Technical Report on ENTSO-E Network Code: Requirements for Generators

Final Report

Submitted to European Commission DG TREN

Project: Technical Report on ENTSO-E's Network Code Requirements for Generators

Figure 3: Power Output, Voltage and Frequency requirements for Generating Units

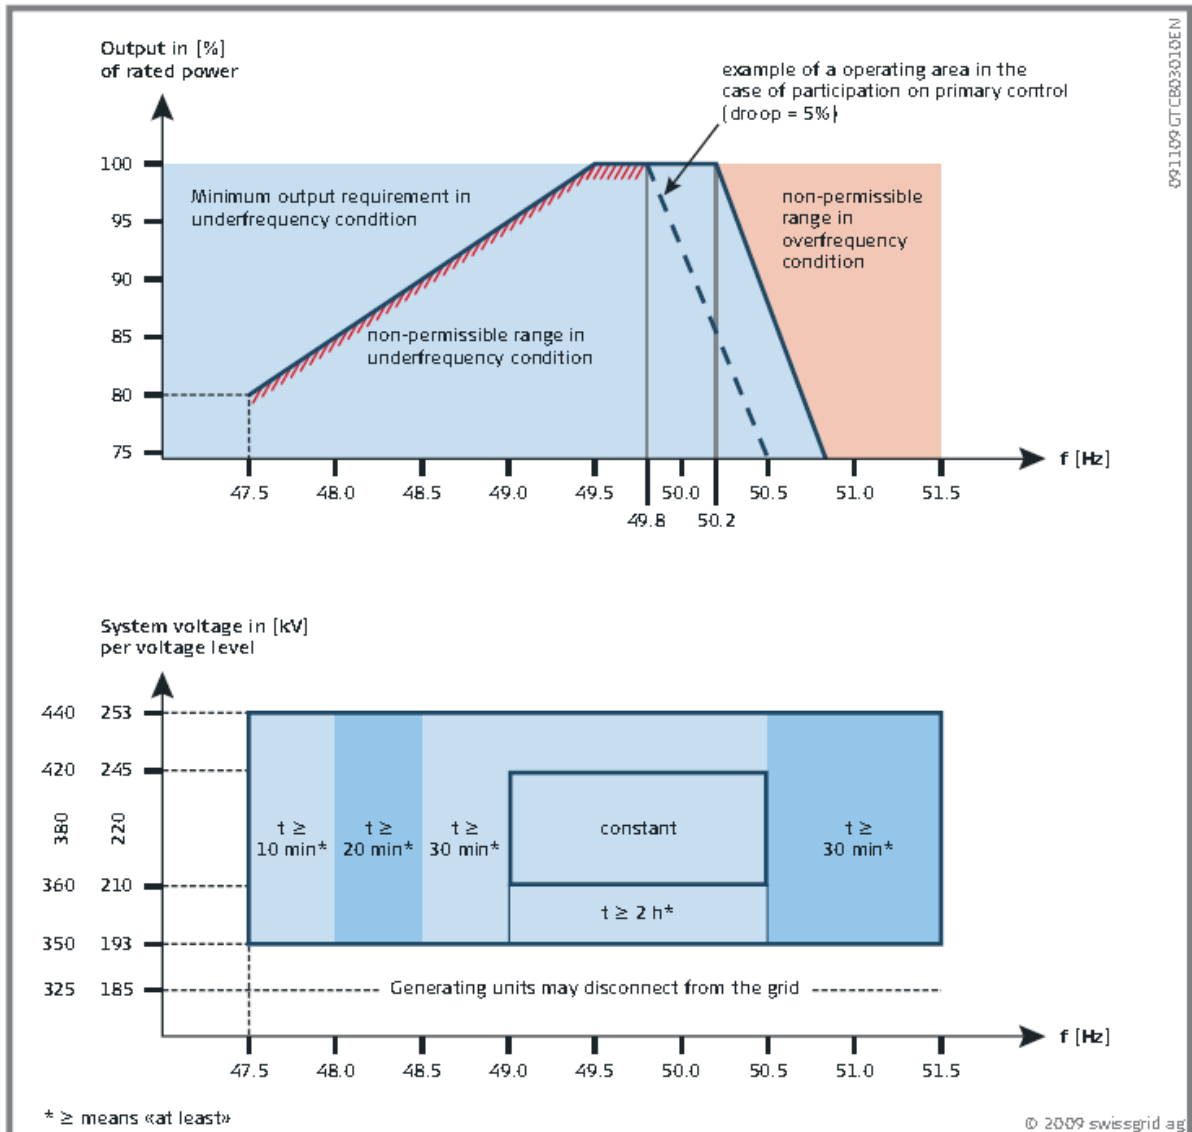
Swiss Grid Code is shown in Figure 3 below. It is noted that, when these combined impacts are established in codes in the ENTSO-E suite, they should reflect current practice if the commitment made by ENTSO-E and ACER regarding the change process is to be met.

To allow for the correct representation of these standards, consideration should be given to incorporating frequency and voltage requirements into a single diagram.

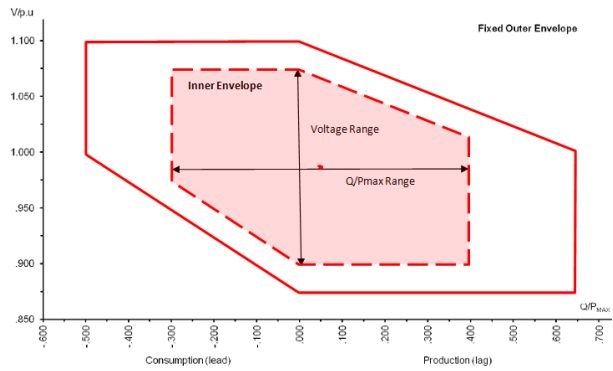
NC RfG Article	13.b.2 Figure 7	Stakeholders Commenting	Thermal Generators, EUR and EU Turbines
Stakeholder Comment	Analysis	Proposal	
Stakeholders comment that the limits proposed by ENTSO-E for reactive power capability are outside the physical capabilities of synchronous generating units	The stakeholders comment is valid in all cases where on-load tap-changers are not used.	<p>The drafting should be modified to allow the existing Figure 7 to continue to be used in TSO areas where it is currently standard practice for on-load tap-changers to be used provided it is normal to employ a sufficient tap range. In other TSO areas, the figure should be amended as shown¹⁶.</p>  <p>Figure 8: Voltage/Reactive Power Profile without OLTC</p>

Being aware of the importance of this issue for power system operations and security, the stakeholders appear only to have commented on areas in these diagrams where there are significant technical constraints preventing operation of their PGMs or where operation under those circumstances may jeopardise their safety provisions or have serious impact on operational or design (or R&D) costs. The fact is that standard generating units cannot supply high reactive power at high grid voltages because of the too high generator voltage caused by the impedance of the step-up transformer and too high excitation current. Also, the absorption capability of reactive power by the generating unit at low grid voltage is less than required because the generator voltage would be too low. Consequently, operation of those generating units in lower left and upper right areas of the proposed envelopes is not recommended by equipment manufacturers as shown in the voltage/reactive power profile in Figure 9 and recognised in the requirements currently contained in the different national codes, presented for justification by ENTSO-E in the document 'Requirement in the context of current practice'. Compliance with the requirements shown in the NC RfG, and included in red in Figure 9, is possible with the use of on load tap-changers with sufficient tapping range, which are not always available even where it is normal practice to install on load tap changers.

- Where OLTCs of sufficient range are in normal use, Figure 7 of the NC RfG as prepared by ENTSO-E should continue to be used.
- In all other areas, TSOs and NRAs should be required, when determining their own shapes, to ensure that the bottom left and upper right areas of the envelope should be avoided.

Figure 12: Voltage/Reactive Power Profile without OLTC

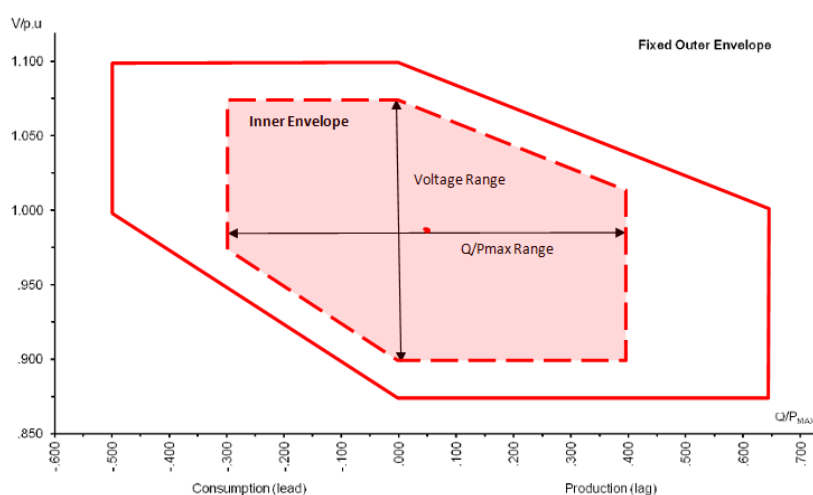
The drafting should be modified to allow the existing Figure 7 to continue to be used in TSO areas where it is currently standard practice for on-load tap-changers to be used provided it is normal to employ a sufficient tap range. In other TSO areas, the figure should be amended as shown²⁴.

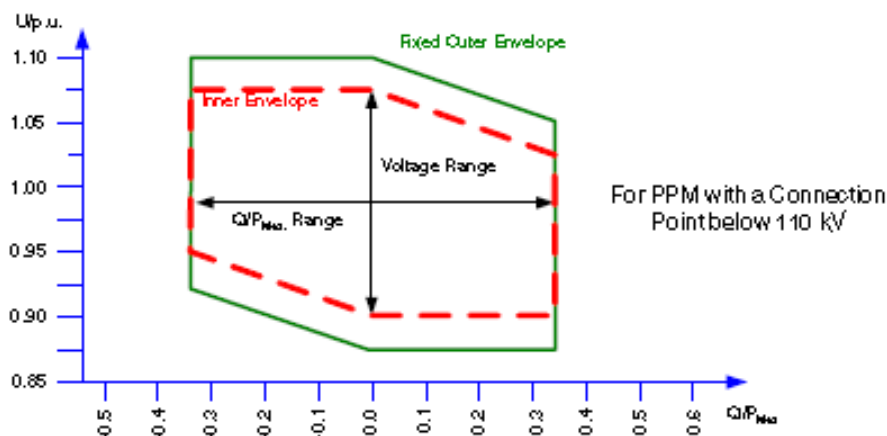
Figure 8 of Article 16 specifies that reactive capability shall be present over a voltage range from +10 to -12.5%. In high voltage grids, a tap changer reduces the large voltage fluctuations. However, for medium voltage connected plant there is no such voltage range reduction. As a consequence, requiring the same voltage operating range for reactive power capability for PPM in medium voltage networks will result in effectively wider voltage ranges than the equipment would be designed for, and thus will lead to increased investment costs for the PPM. Because there is no technical necessity for such a requirement, there will be hardly any use for this extended capability. If this NC requirement is universally applied in Europe, a large amount of investment in reactive capability will become stranded.

- Reactive power capability at maximum capacity: paragraph Article 16.3 b)2), to add the graph Figure 8bis and table 9bis, and to modify the text of the paragraph to include proper references to this figure and table.
- Reactive power capability below maximum capacity: paragraph Article 16.3 c)2), to add Figure 9bis, and to modify the text of the paragraph to include proper reference to the figure.

Diagram proposed by VGB / EURELECTRIC during the public consultation of the RfG code.

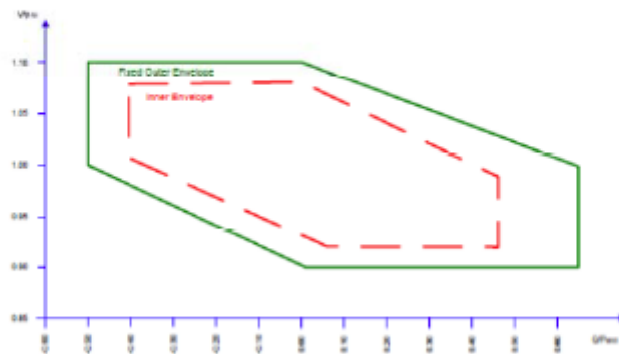
VGB / EURELECTRIC propose the following reactive power capability as a minimum requirement (red envelope) included in a maximum standard requirement (green envelope). If TSO's needs are larger at a specific location, then a CBA should shed light on where would be the best choice to implement the extra reactive power capability.

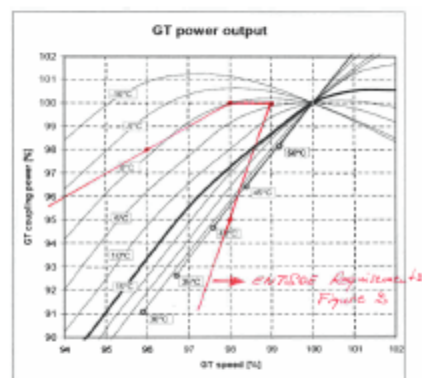
This graph from Siemens shows the power output of a gas turbine at falling frequencies for various ambient temperatures. The requirements according to Art.8 (Figure 2) are outlined in this graph. The conclusion is that the capacity decreases also for frequencies outside the area requested by the code.

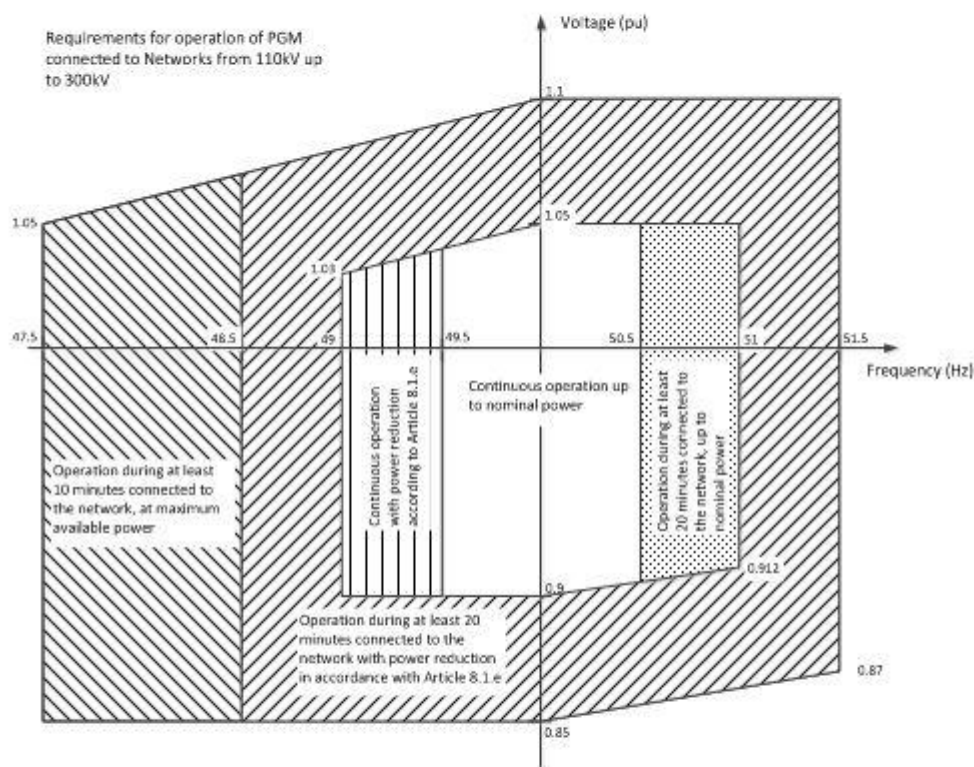
We propose to the following amendments to the draft code:

- Delete the article 8.1.a.1 and Table 2.
- Delete the article 11.2.a.1 and Tables 6.1 and 6.2
- Add a new article with the proposed diagrams (diagrams attached are valid for Continental Europe, we offer to prepare similar diagrams for other synchronous areas).
